Project Assessment Review of the Draft Report

Review of the Project Group:
Group Code: AP1000 51
Full title: AP 1000

SH2702 - Nuclear Reactor Technology
Master programme in Nuclear Energy Engineering

AP 1000

Figure 13: Axial pressure drop in average and hot channel.

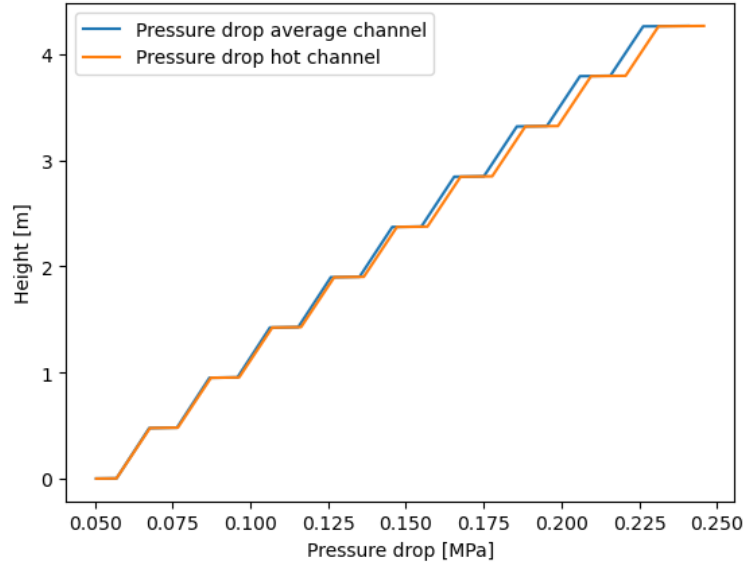
| Intended learning outcome (ILO) | Grade (0-3) | The explanation for the grading of the evidence of achieving respective ILO. Suggestions for improvements and other comments |
|--|-------------|---|
| 5. <i>Calculate</i> CHF margins in a hot channel (Task 5, ILO4a) | 3 | A brief explanation of CHF and DNBR. Shouldn’t the height be the abscissa/x-axis in Fig. 13? |
